To: Josh Mihaly, RLA
From: Nicole Smith, Associate Planner; 910-341-1611
CC: File;
Date: 6/25/2020
Re: The Mini Pearl Landscape Modification

■ THE MINI PEARL [Landscape Plan Review]

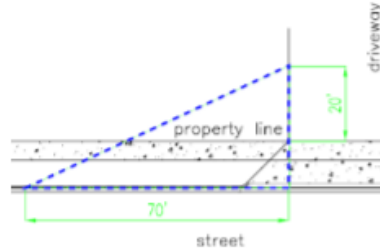
The proposed layout of the 6 live oaks in the 4th St. ROW is not going to be acceptable. They are overcrowded and will cause major issues later on, interfering with each other and the roadways. I'd say no more than two, maybe three, live oaks in that area would be the maximum acceptable.
